**Tooling Research and Application Department**  
**Dr. Viktor P. Astakhov**

**Part and Feature:** Threading tap by XXXXXXXX

**Problem:** Broken tool.

**Figure 1.** Broken tab in the MC

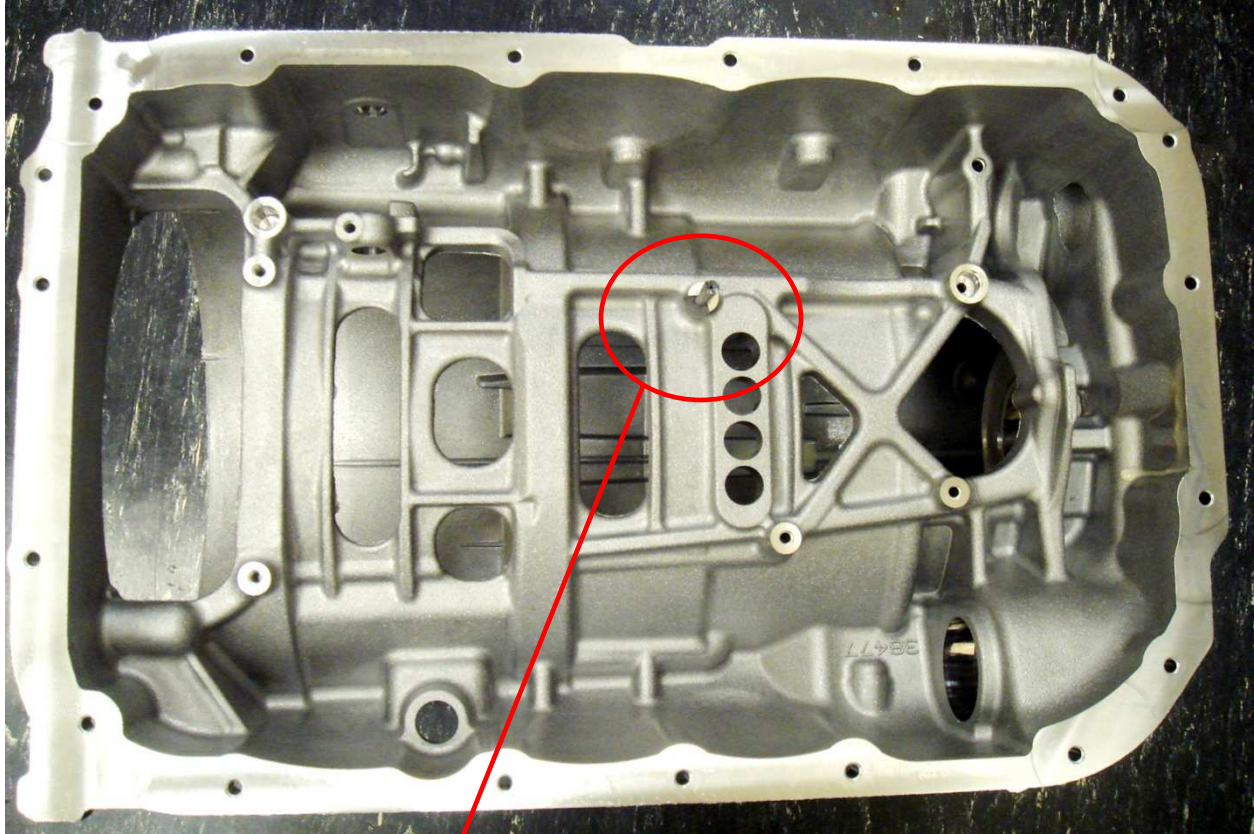
Figure 1 shows the failed tap that stuck in the case. As clearly seen, the shank of the broken tap interferes with the hole being tapped. This interference caused tap breakage. Analysis of the tap drawing (Figure 2) shows that the neck length (the distance from the end of the tap to the shank) should be 36mm. Moreover, one of the production notes on the drawing states **“Extend neck length per print.”**

Figure 2. Tool drawing

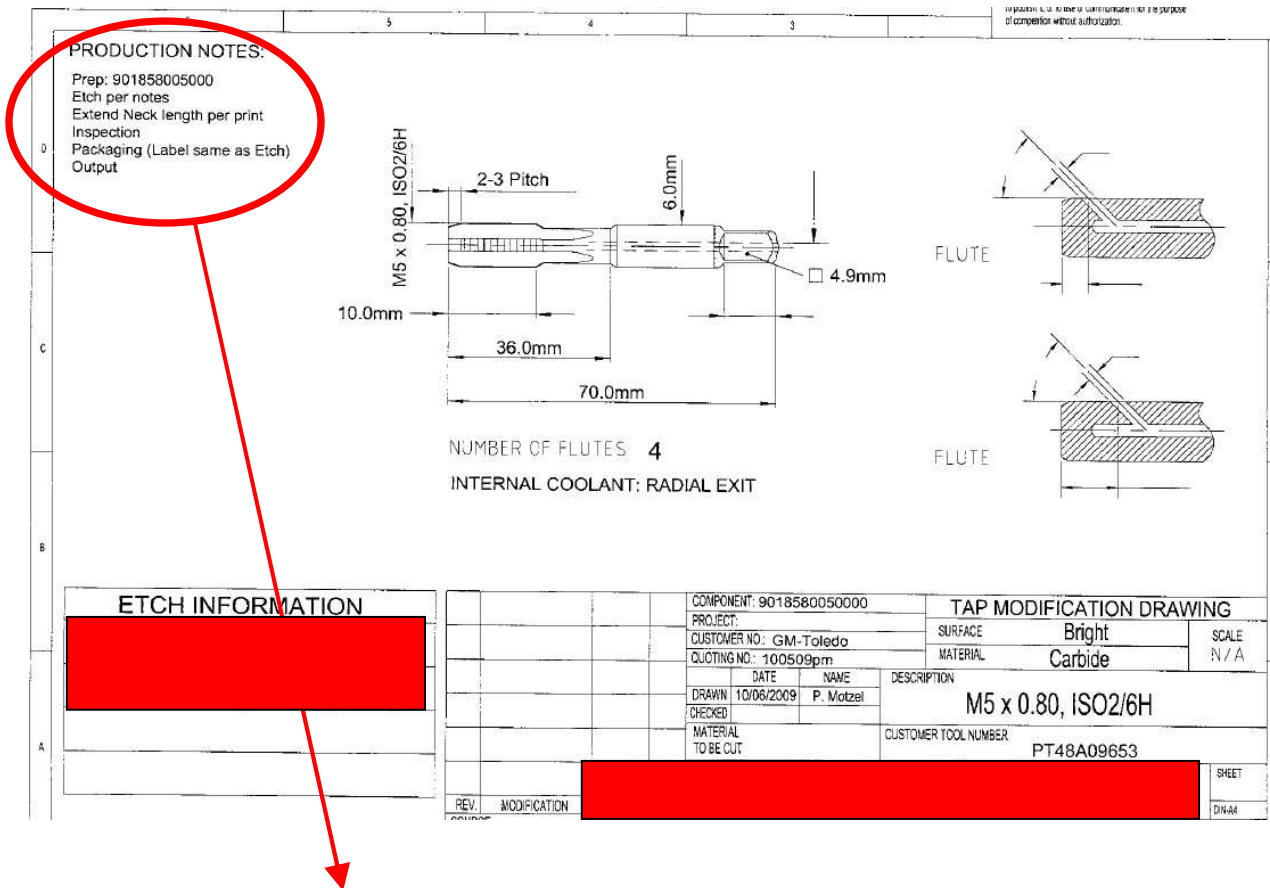
Extend Neck length per print

**Figure 3.** The actual (above) tap having neck length of 26 mm and the correct tap (below) having neck length of 36 mm according to the drawing shown in Fig.2

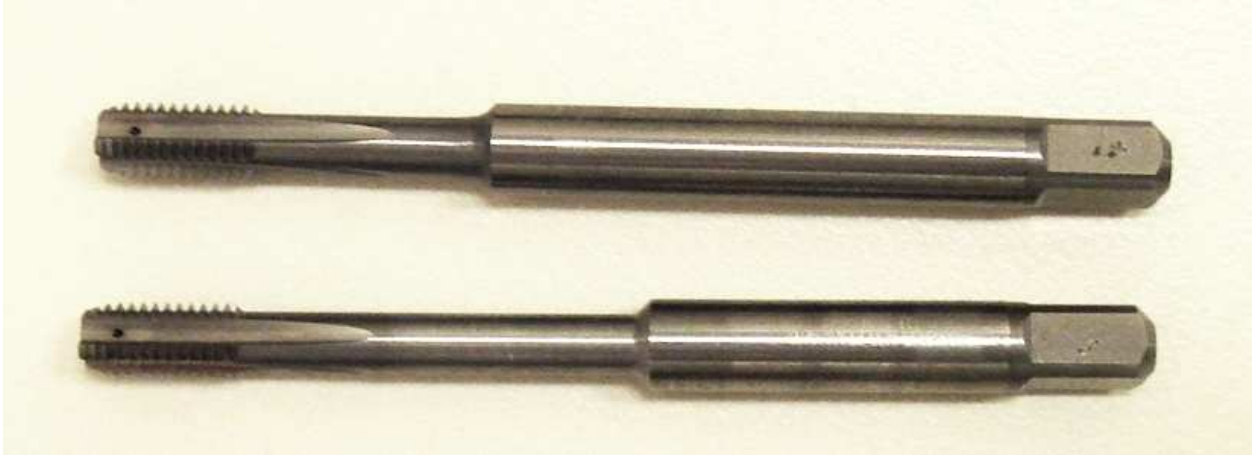
The measurement of the actual tap set for the operation showed that the neck length of this tap is 26mm. Figure 3 shows the comparison of the actual tap having neck length of 26 mm and the correct tap having neck length of 36 mm according to the drawing shown in Fig.2. Therefore, the **root cause** of the problem is insufficient neck length of the tap. In other words, the taps sent to PSMi are not according to the drawing.
